From: Planning
Sent: 03 June 2026 16:16
Subject: FW: DISC/26/0037 - Cowfold - Planning Conditions Update
Attachments: RE: DISC/26/0037 Land North of Little Potters, Potters Green, Station Road, Cowfold - LLFA comments - Tullys initial reply

From: Paul Tittle [REDACTED] >
Sent: 28 April 2026 16:26
To: Flood Risk Management <FRM@westsussex.gov.uk>
Cc: [REDACTED]
Subject: DISC/26/0037 Land North of Little Potters, Potters Green, Station Road, Cowfold - LLFA comments - Tullys initial reply

Advisories

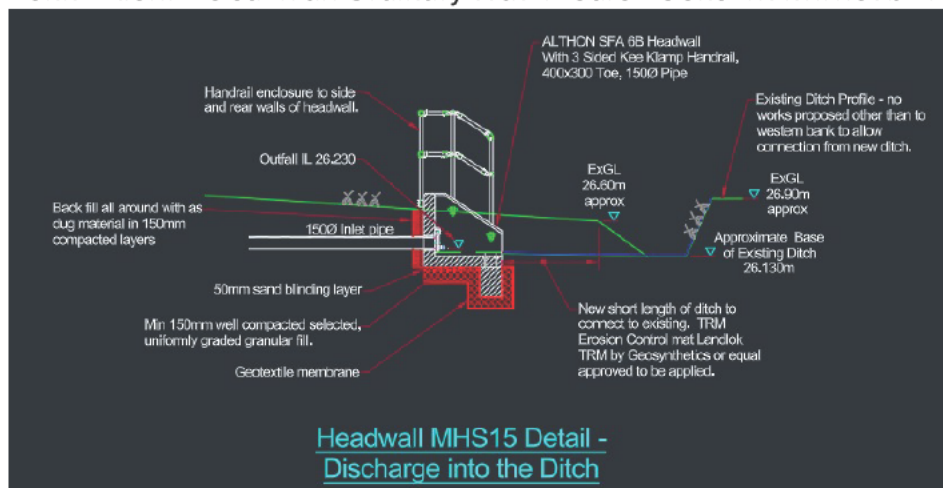
2. This is a dry detention basin with up to 2.1m temporary water depth above the dry base with 300mm minimum freeboard above this maximum water level. This is all as the planning approved drainage strategy. During discussions with the proposed S104 adopting authority (AWIN) a low flow channel has now been added to direct low intensity, small volumes of rainwater through the basin. This does increase the maximum water depth up to $0.3 + 2.1 = 2.4\text{m}$ but the greatest depth occurs only directly above the 750mm wide low flow channel; outside of this channel the max water depth remains at 2.1m above the dry base.
3. 6% urban creep noted, so no changes are required.

1. The plan is correct. We will update the section to suit. This will show that the new headwall is set back from the existing ditch. A short length of new ditch will be provided so that the only works required to the existing ditch will be to break through the western bank to make the new connection. As such an Ordinary Watercourse Consent will not be required.
